## **Economic Commission for Europe**

**Informal Ad hoc Expert Group on Conceptual and  
Technical Aspects of Computerization of the TIR Procedure**

## **Amendments to the eTIR conceptual, functional and technical documentation - v.4.2a**

**Note by the secretariat**

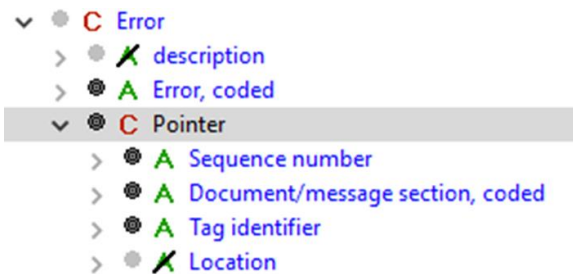
7. The figure below shows the structure of a declaration message, in which an erroneous code has been used to describe the package type, in the third Consignment Item of the second Consignment

8. The first option uses classes and attributes WCO IDs to point at the error. The pointer class is repeated until the Packages type description code is reached, as shown in the table below:

9. The second option uses the so-called “Unique position Id”, which allows to identify a class used at different places in the data model. However, in case of multiple occurrences of a class in a message, the pointer still needs to be repeated to identify the correct sequence number of the class. The table below show how this option is implemented in practice:

10. Finally, since version 3.7 of the WCO data model, a new attribute has been added to the pointer class: “Location”. As shown in the figure below, the location attribute is not used so far in eTIR messages.

11. The location allows to point at an error or an amendment using an XPath. The following two tables show how this can be implemented in practice using either the classes and attributes XML tags or the WCO IDs:

12. GE.1 might wish to discuss the various options and select the most appropriate option to use of the pointer class for both errors and amendments and, if necessary, instruct the secretariat to make the relevant changes in all eTIR specifications.
